UNITED STATES PATENT AND TRADEMARK OFFICE

10/797,149

Office Action Summary	Application No. 10/797,149	Applicant(s) OHAMA ET AL.	
	Examiner MICHAEL C. MCCULLOUGH	Art Unit 3653

DETAILED ACTION

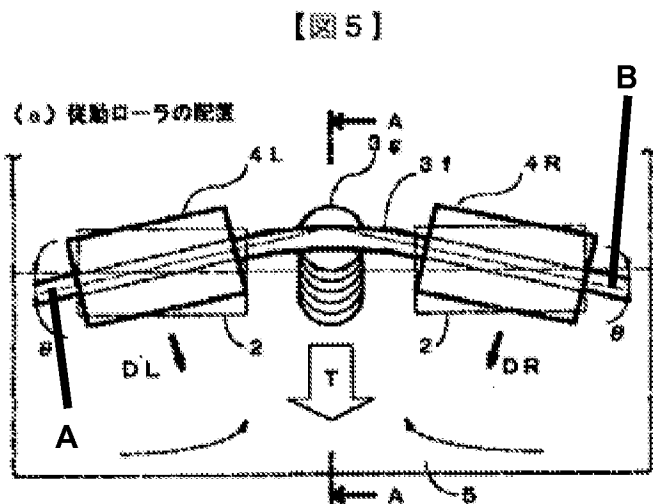
2. Claim 18 is rejected under 35 U.S.C. 102(b) as being anticipated by Masaaki (JP 2001310857). Masaaki discloses a processing device comprising a first drive shaft (see Figure 5b) with drive rollers (2), a second drive shaft (3f) with at least two segments (see Figure 5a elements A and B, below) with a driven roller (4R,L) mounted on each segment, a centermost portion of the second drive shaft is more downstream than the first drive shaft and an outermost portion of the second drive shaft is more upstream than the first drive shaft .

FIG. 1

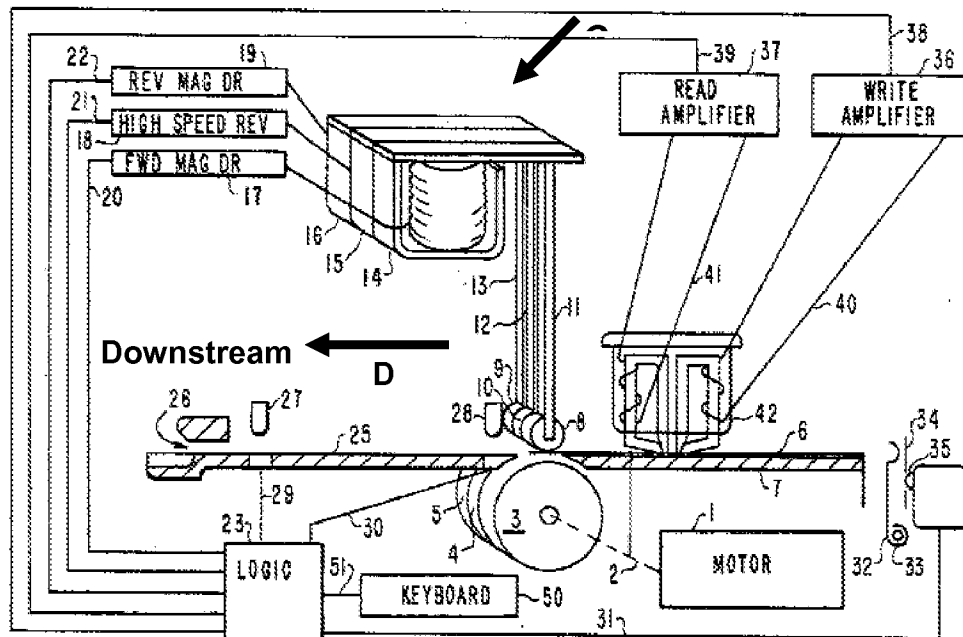
3. Claims 1, 3, 6-8, 10, 21, and 22 are rejected under 35 U.S.C. 103(a) as being unpatentable over Fowler et al. (US 3,66,262) in view of Sako et al. (US 6,073,927). Fowler et al. discloses a sheet feeder in an image reading apparatus comprising an image reading part (37), a drive roller unit (3, 4, 5) with an axis (2) perpendicular to the sheet feed direction (see Figure 1 arrow D, below) that includes driven rollers and is immediately downstream from the image reading part, a driven roller unit (see Figure 1 element C, below) with the same amount of driven rollers (8, 9, 10) as drive rollers arranged symmetrically with respect to a center line (see Figure 3a line E, below) with axes on a slant (8a and 10a) such that the end portion of each axis far from the center of the width is upstream and the close to the center is downstream, an urging member that urges segments of the driven roller unit independently (see column 3 lines 20-27), and a straight conveying path (7 and 25). Fowler et al. does not disclose the drive roller

has a coefficient of friction greater than a coefficient of friction of the driven rollers and a conveying pair upstream from an imaging part and a curved conveying path. However, Sako et al. discloses a similar device that includes the drive roller has a coefficient of friction greater than a coefficient of friction of the driven rollers (see column 6 lines 13-20), a conveying roller pair (22 and 21), and a curved conveying path (23) for the purpose of easily sliding against each other (see column 6 lines 13-20), separating a sheet (see column 4 lines 56-63), and guiding a sheet. It would have been obvious for a person of ordinary skill in the art at the time of the applicant's invention to modify Fowler et al. by utilizing drive rollers with a coefficient of friction greater than a coefficient of friction of driven rollers, a conveying pair, and a curved conveying path as disclosed by Sako et al., for the purposes of easily sliding against each other, separating a sheet, and guiding a sheet.

FIG. 3a

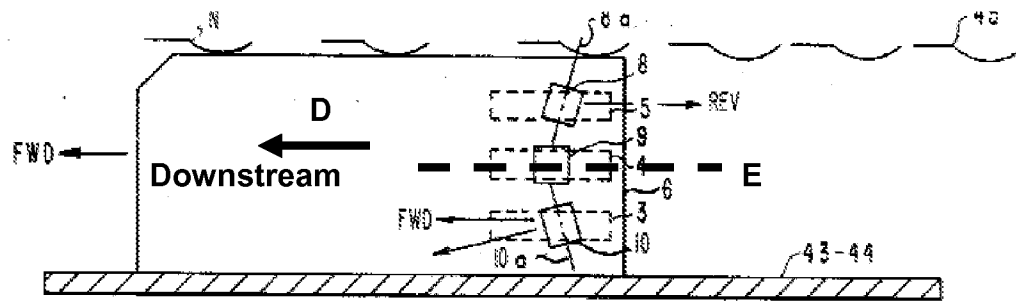
7. Applicant's arguments filed 03 June 2008 have been fully considered but they are not persuasive. Applicant argues, with respect to claim 1, that the drive rollers (3, 4, and 5) of Fowler are upstream from the reading amplifier (37) and not immediately downstream as claimed. In response, Fowler discloses that the sheet is moved both forward and reverse, see column 3 lines 20-26 and Figure 3a; therefore, the drive roller unit is downstream from the image reading part.
